Access Compliance Report

Public Rights-of-Way

(Curb Ramps)

Intersection ID: 3245	Main Street: HERITAGE_HILLS_LN	Cross Street: MARATHON_HILL_RD	Location: SE
ADA ID: A1B2CEF269A7	Ramp Type: Perp	Initial Pass/Fail: Fail	Overall Compliance: No
Severity Score: 8.75			
Codes/Mitigation Info/Possible Solution		Field Measurements/Component Compliance

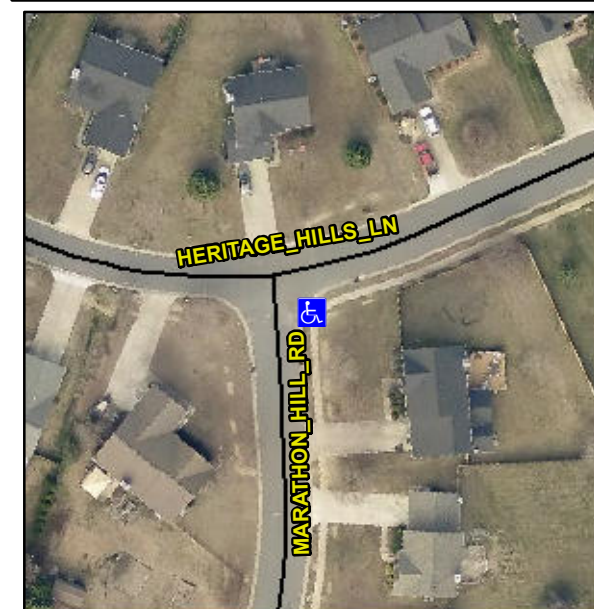
R304.5.1

Compliance	Description	Data	Compliance	Description	Data
N/A	Ramp Length (in)	48.0	Yes	Ramp Slope (%)	5.2
No	Ramp Width (in)	44.0	Yes	Ramp XSlope (%)	0.9
N/A	Flare Type LT	N/A	N/A	Flare Type RT	N/A
N/A	Flare Slope LT (%)	N/A	N/A	Flare Slope RT (%)	N/A
N/A	Flare Traversable LT?	N/A	N/A	Flare Traversable RT?	N/A
N/A	Landing Length (in)	N/A	N/A	DWS Provided?	N/A
N/A	Landing Width (in)	N/A	N/A	DWS Contrast?	N/A
N/A	Landing Slope (%)	N/A	N/A	DWS Length (in)	N/A
N/A	Landing X Slope (%)	N/A	N/A	DWS Full Width?	N/A
N/A	Landing Curb? (Y/N)	N/A	N/A	DWS Offset (in)	N/A
N/A	Shared Landing?	N/A			
N/A	Gutter Ponding?	N/A	N/A	Gutter Slope (%)	N/A
N/A	Gutter Lip Ht (in)	N/A	N/A	Gutter X Slope (%)	N/A
N/A	Painted X Walk1?	No	N/A	Painted X Walk2?	N/A
	X Walk 1 Direction	To N		X Walk 2 Direction	N/A
N/A	X Walk 1 Width (in)	N/A	N/A	X Walk 2 Width (in)	N/A
	X Walk 1 Slope (%)	0.3		X Walk 2 Slope (%)	N/A
	X Walk 1 X Slope (%)	0.6		X Walk 2 X Slope (%)	N/A

Remove & Replace Entire Ramp.
